SUBJECT: **Second Supplemental Report for BZA Case No. 19169 - 317 K Street NW**

**MODIFICATION OF SIGNIFICANCE
BIRCHINGTON, LLC**

**BZA ORDER #19169C
303-317 K STREET NW**

LOADING VARIANCE SUPPLEMENT

Figure 2 Parking Inventory Map (Source: Grove/Slade)

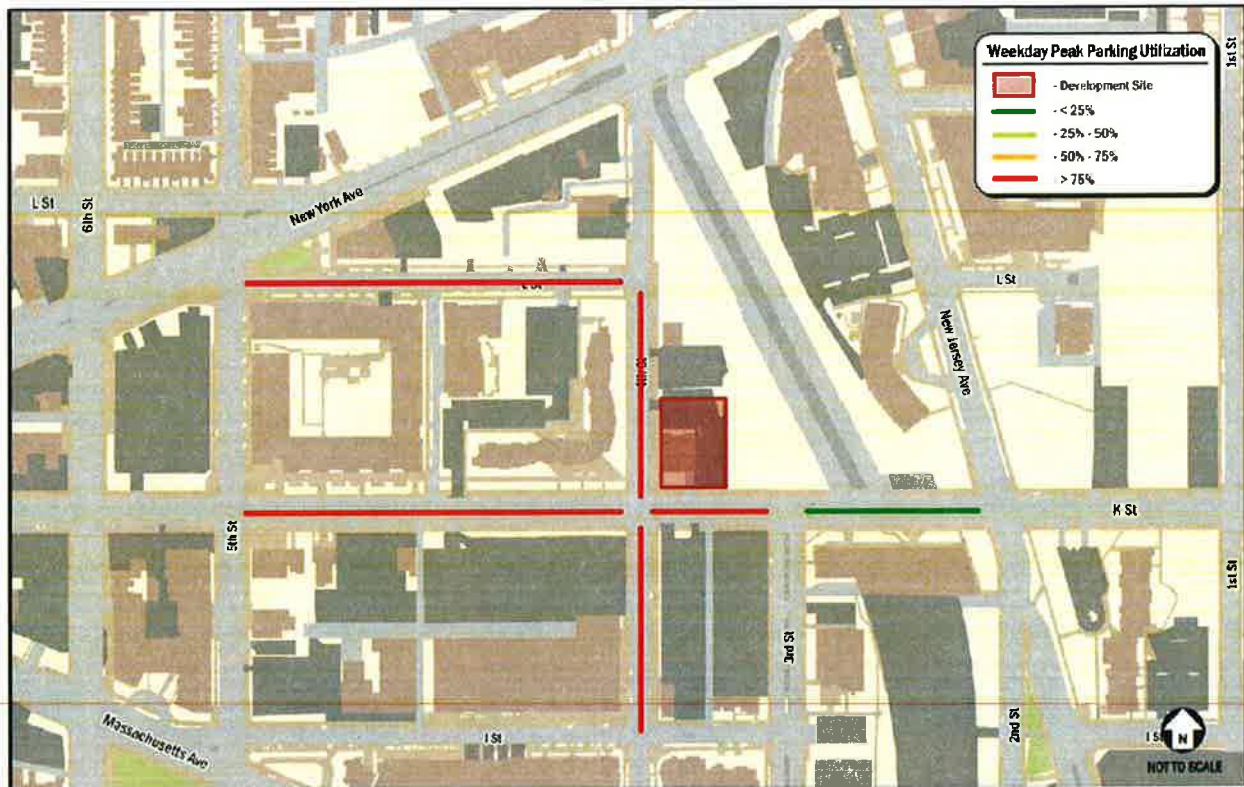
The inventory noted a total of 146 curbside parking spaces in the vicinity; 18 non-metered, 22 RPP, and 106 metered spaces. The spaces located adjacent to the subject site on 4th Street and K Street are metered. The parking inventory is illustrated in Figure 2.

Within the observation period, the peak parking utilization occurred at 8:00pm when 91% of all spaces in the vicinity were occupied. Of note, the 18 non-metered spaces identified in the analysis are located

on the K Street bridge over I-395 where parking is prohibited. Therefore, the parking inventory revealed 100% utilization of legal parking spaces in the study area.

The results of the Applicant’s curbside inventory indicate that curbside parking availability is insufficient to accommodate any potential spillover parking from the site. Due to the high availability of excellent non-auto transportation options, it is likely that auto usage by residents and hotel guests will be low and the proposed on-site parking supply is likely to be sufficient. In the event that demand for parking is higher than anticipated, the Applicant obtained letters of intent from four nearby parking facilities that identify sufficient parking availability for potential valet service usage by the subject project. The availability of parking spaces in private parking facilities in the vicinity would provide sufficient parking if parking demand should exceed available on-site parking supply.

Figure 4 Site Plan (Source: PGN Architects)

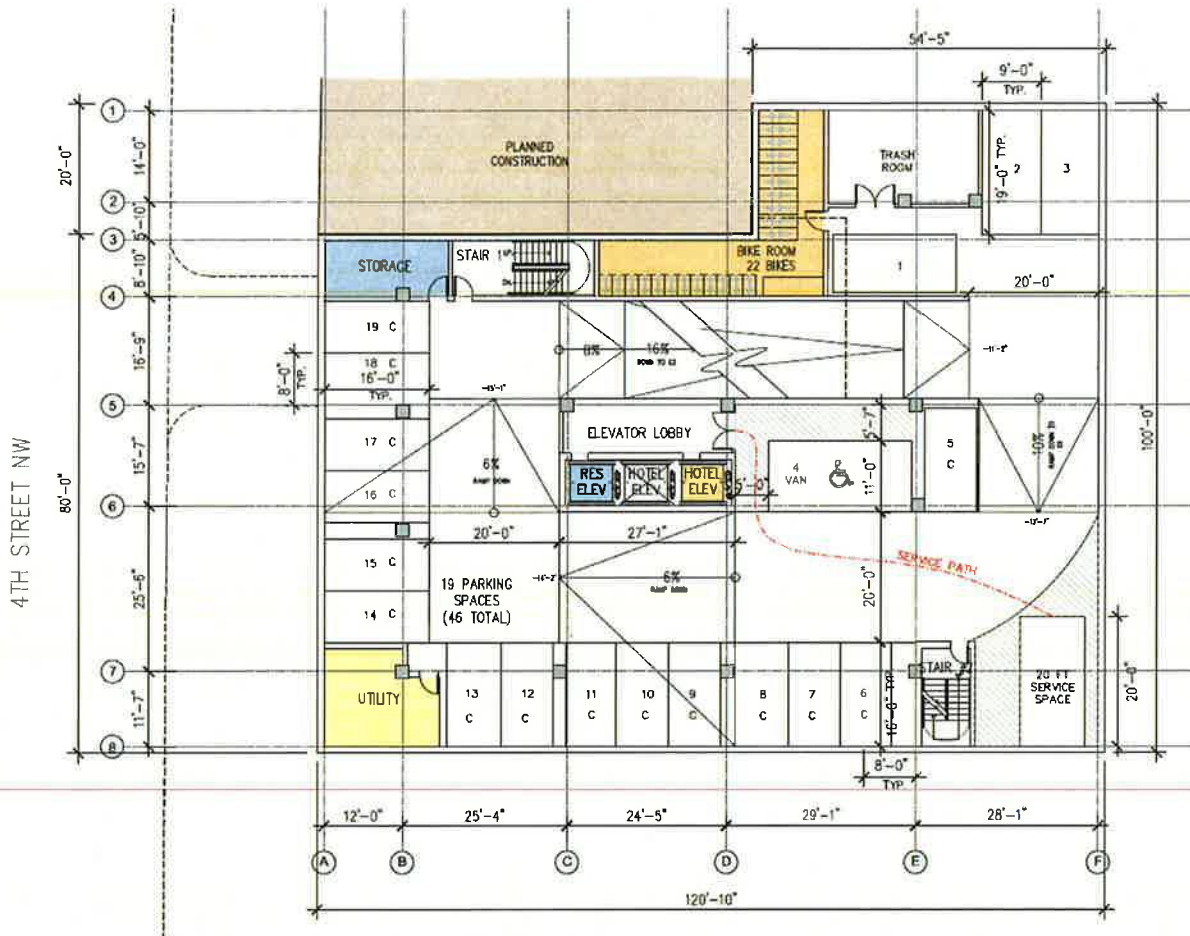
DDOT's Design and Engineering Manual prohibits truck backing maneuvers through public space. The Applicant coordinated with DDOT on several site design schemes with different attempts to accommodate the loading facilities in a manner consistent with DDOT standards. Ultimately, due to the relative small size of the lot and the desire to avoid creating a curb cut on K Street, DDOT determined that a 30-foot loading berth could not be accommodated on-site without backing maneuvers. The Applicant proposes to accommodate loading via a combined curbside loading zone on 4th Street that may also be used for valet operations as shown in Figure 4. A service corridor would connect the

proposed curbside loading area to the buildings back of house area. Earlier versions of the site plan did not include this corridor, but the Applicant revised the site plan to include this facility.

The Applicant and DDOT coordinated closely to create a functional 20-foot service/delivery space. The space is located on the same level as and is in relatively close proximity to the core. Such a design results in a loading space that is likely to be utilized for deliveries and will accommodate some on-site loading activity while lessening the demand placed on curbside loading.

The Applicant must submit a formal loading zone request to DDOT and will also need a public space permit to occupy the curbside for a valet staging zone. DDOT's lack of objection to the loading variance request does not constitute approval for the curbside loading zone or valet staging zone. DDOT will evaluate the requests through the aforementioned processes to determine their validity. The Applicant must continue to coordinate with DDOT to determine appropriate design and operations of the potential combined commercial loading and valet staging proposal. Any proposal would need to be designed and operated in a way such that impacts to the existing curbside are minimized through time-of-day restrictions and combined uses that would use less space overall compared to an individual commercial loading zone adjacent to a separate valet staging zone.

- Instruct any delivery using a truck 20 feet in length or shorter to use the on-site service delivery space.
